REPORT TO DESIGN COMMISSION City of Sacramento

PUBLIC HEARING
May 19, 2010

Subject: **625 H Street (DR10-033)** Located at the northwest corner of 7th and H Streets, a request to develop an eight story mid-rise 150 unit residential tower including 2,800+/- s.f. ground floor retail and 6,000 s.f. health clinic on 0.55+/- acres in the Central Business District Special Planning District (C-3-SPD) zone.

D2-2

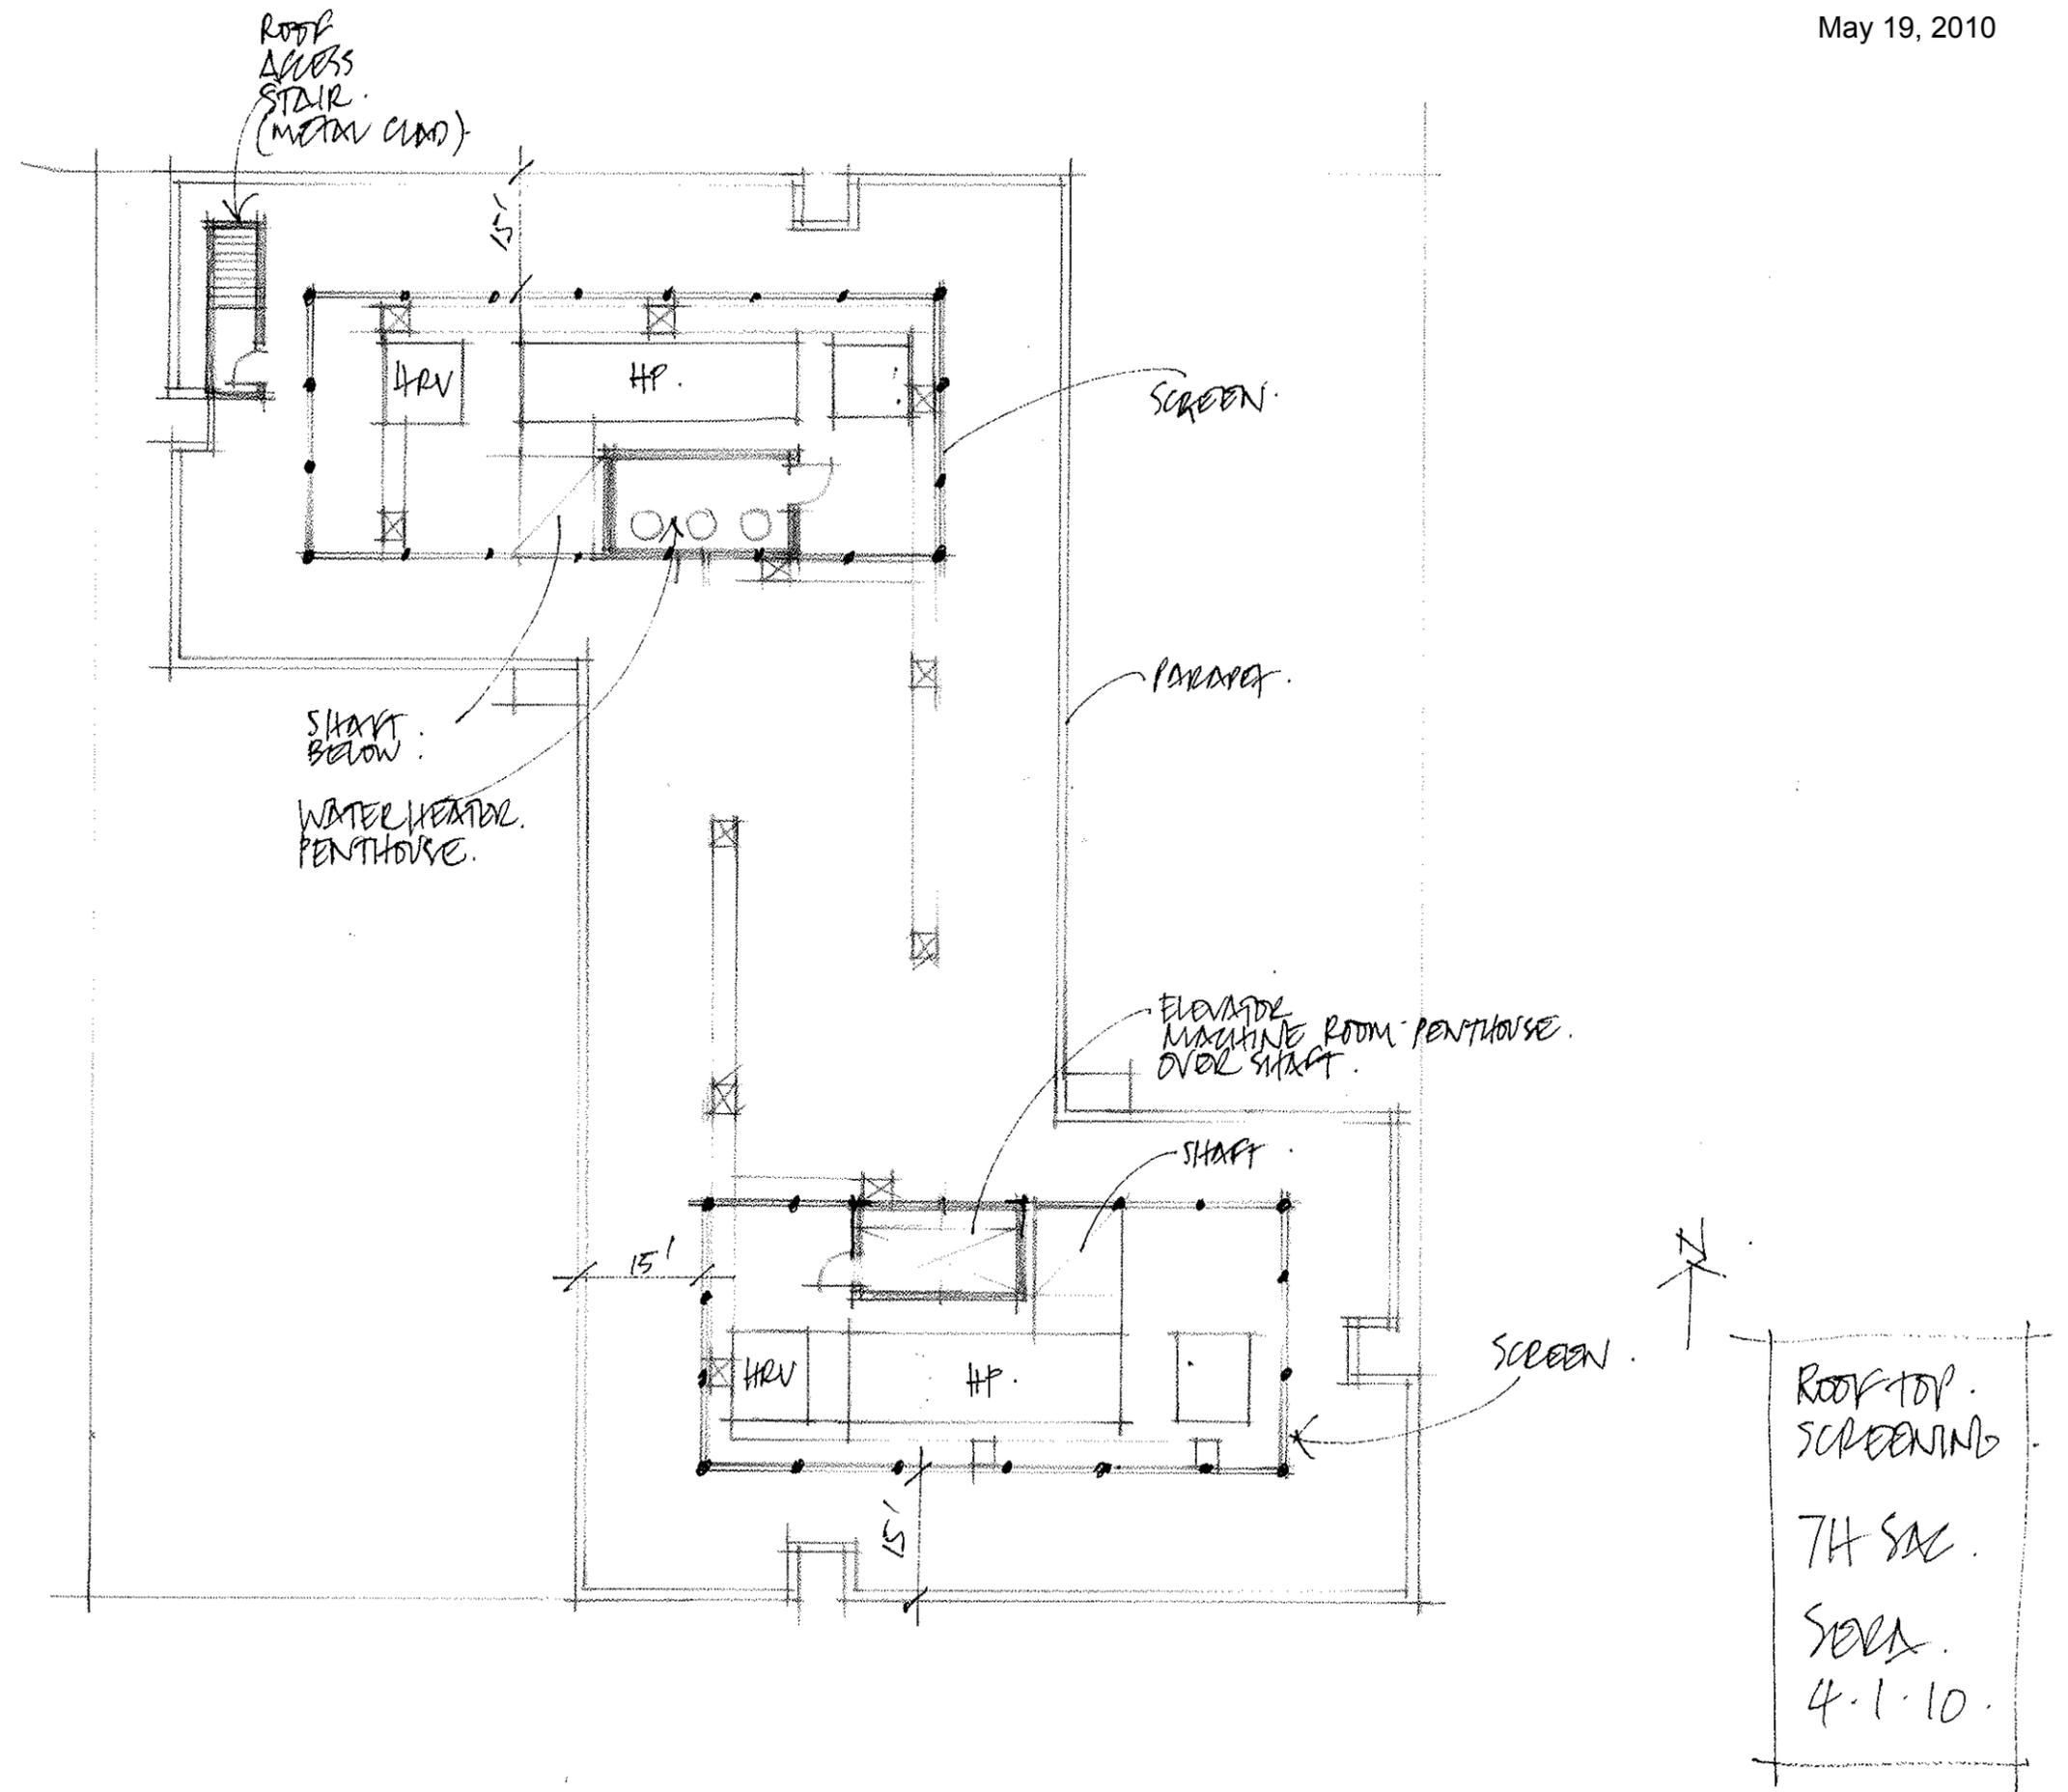
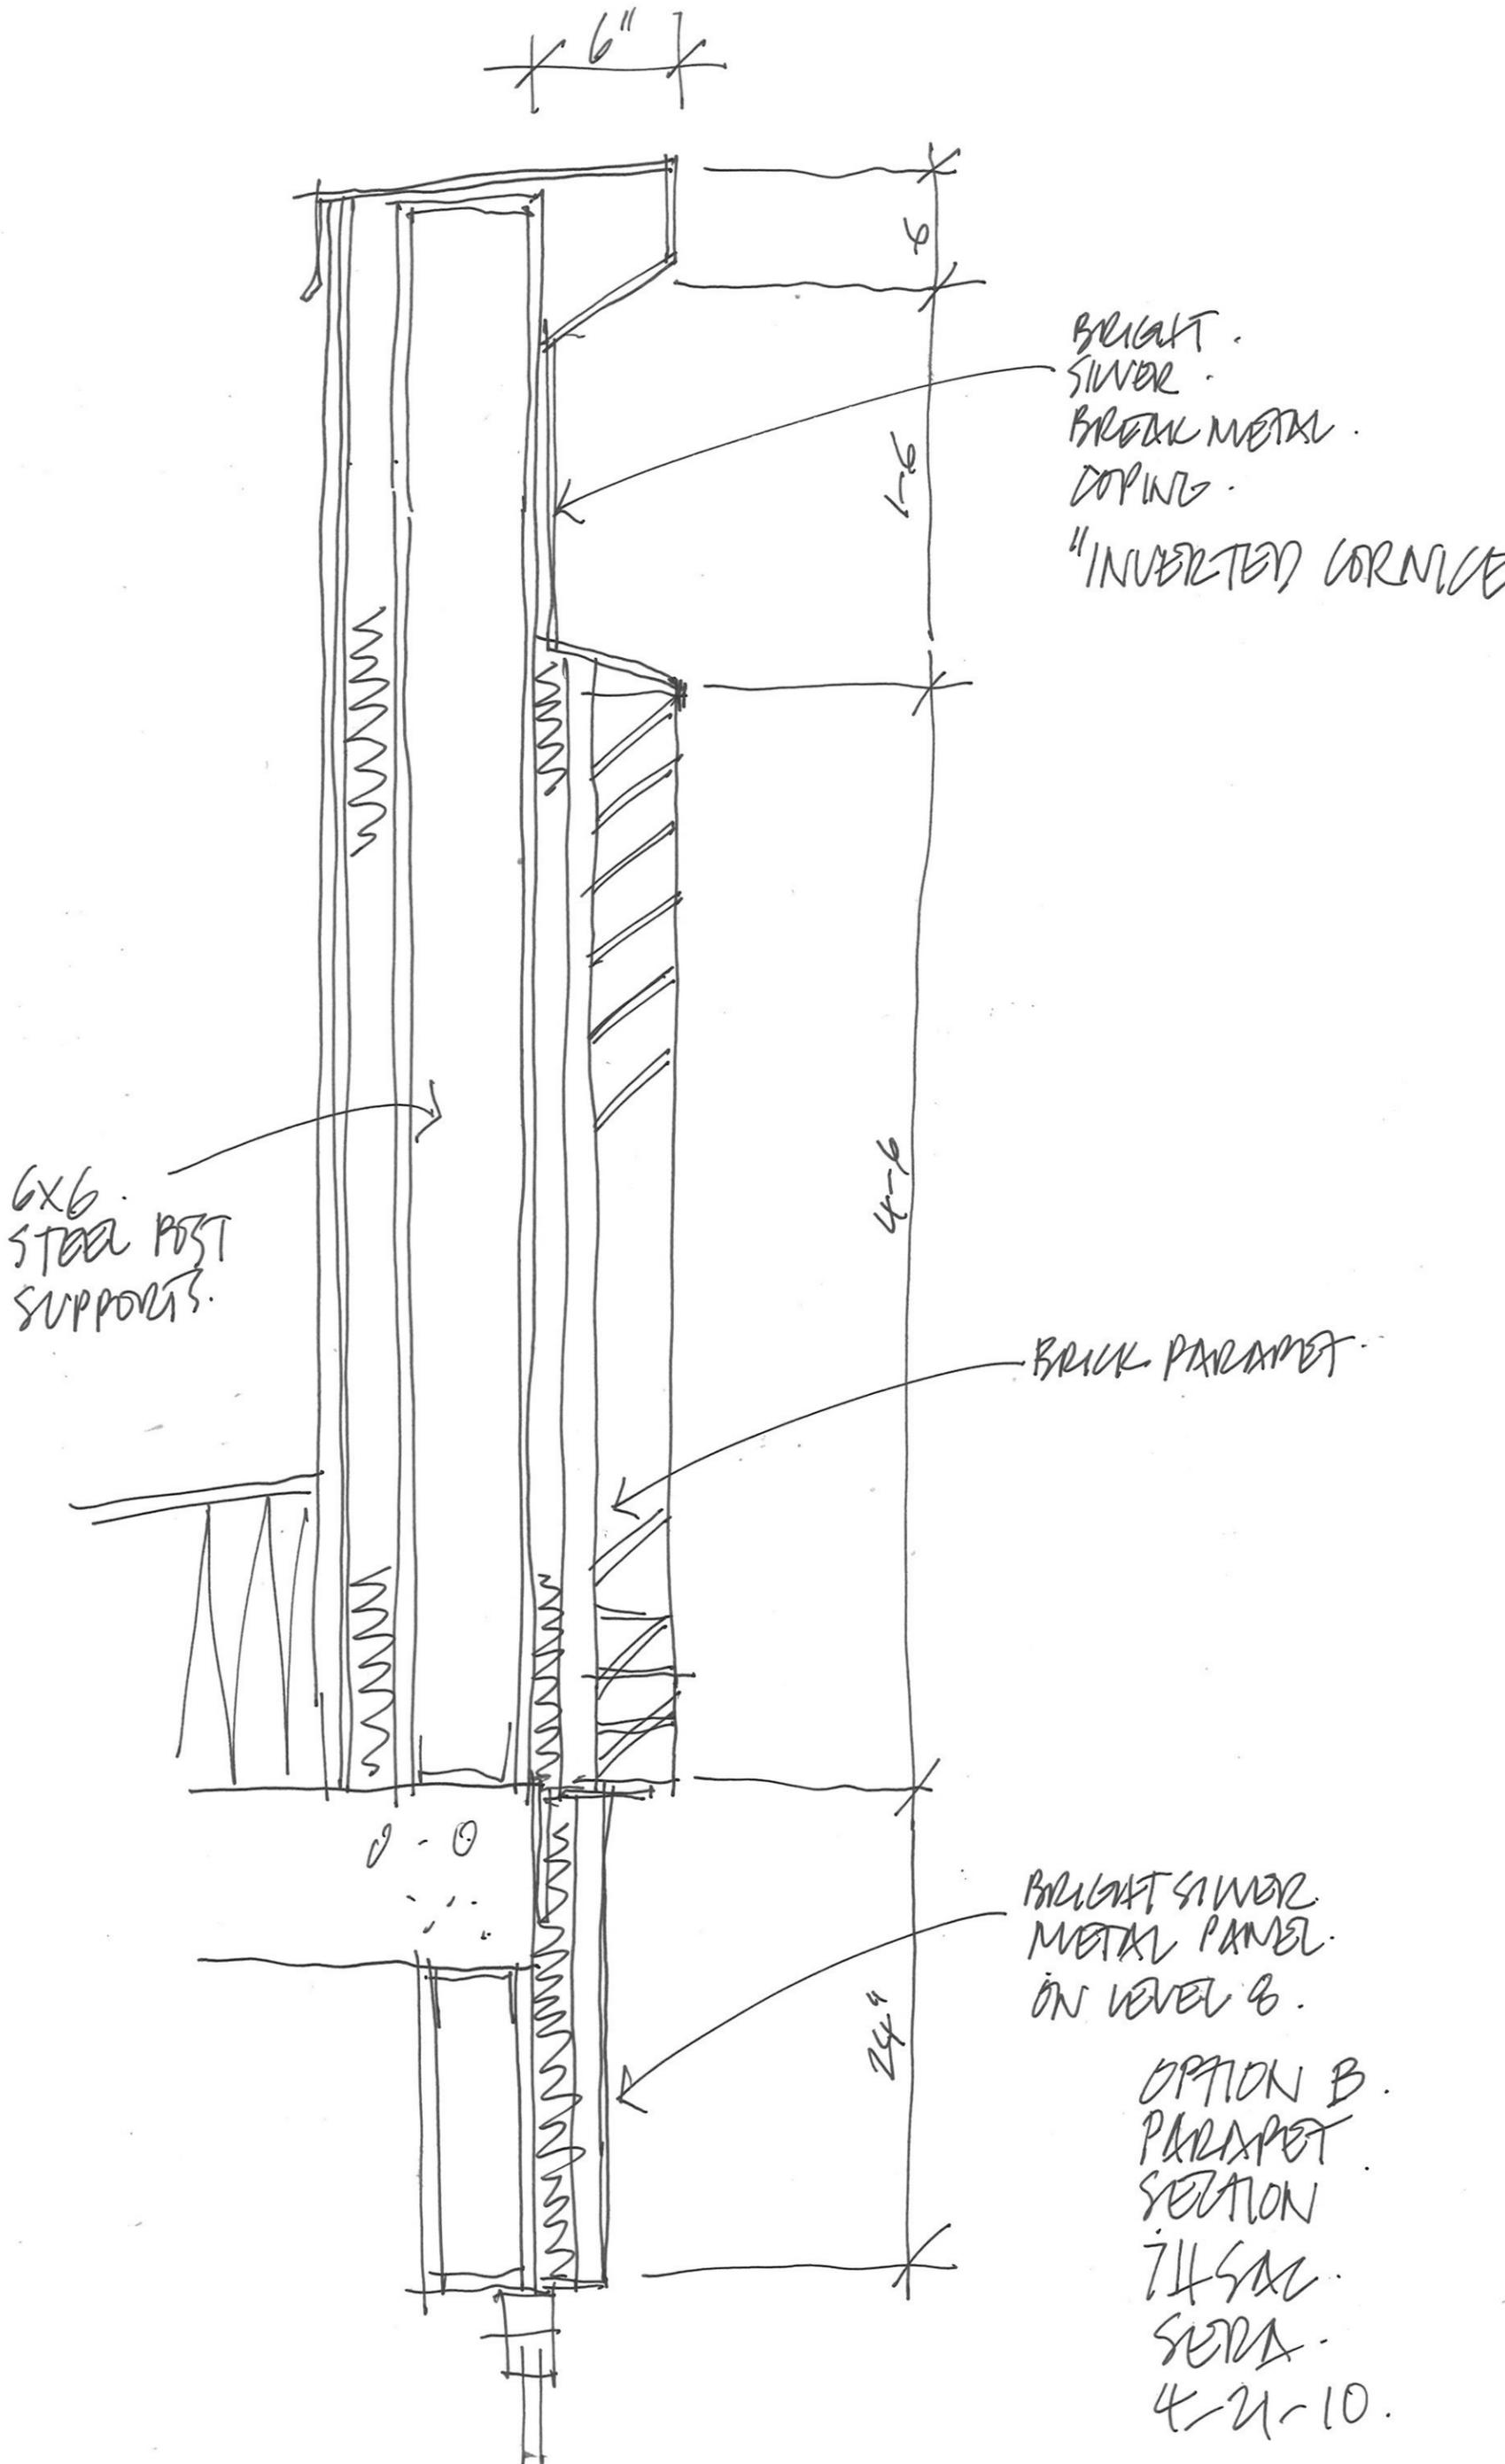
7. The prevalent views from I-5, Railyards, and general city skyline will require additional refinement/treatments of the building top and mechanical penthouses. Please provide revised plans incorporating the mechanical penthouse and the building top (cornice) as an integral part of the building regardless of the PV array as the proposed elements need further refinement and articulation.

- b. The cornice (“building top”): With or without the solar array, the cornice has been altered to include a 2’ tall metal coping with a deep reveal to create a shadow line. A detail sketch of the parapet has been added to the submittal. **See exhibit DR2-5**.
